PREVOST

95-01

Warranty Bulletin

Date: **January 1995**
Section: **12**
Subject: **INSTALLATION OF A PARKING BRAKE BUTTON PROTECTOR**
Application:

Figure 1

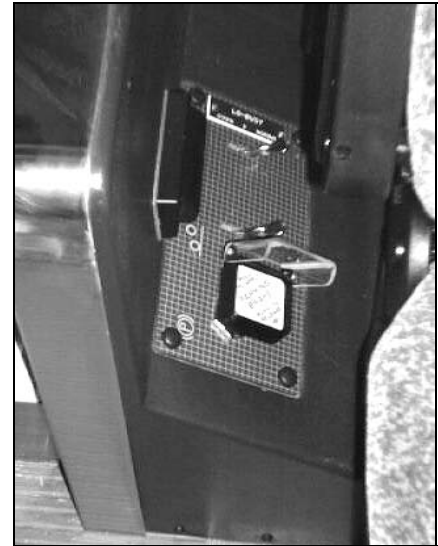
1. Drive the button roll-pin out with a punch and remove the parking brake button.

Note: The parking brake is located on the right-hand console, right of driver's seat. See figure 1.

2. With parking brake button in protector oriented so roll pin can be installed (the new yellow button for vehicles equipped with the black one), put protector in place. Secure it by installing the roll pin.

Note: The operation of the parking brake will be modified by the addition of the protector. To apply parking brake, lift protector clw button; to release parking brake, open protector cover and push yellow button.

Note: The parking brake button and its protector are completely pivoting.
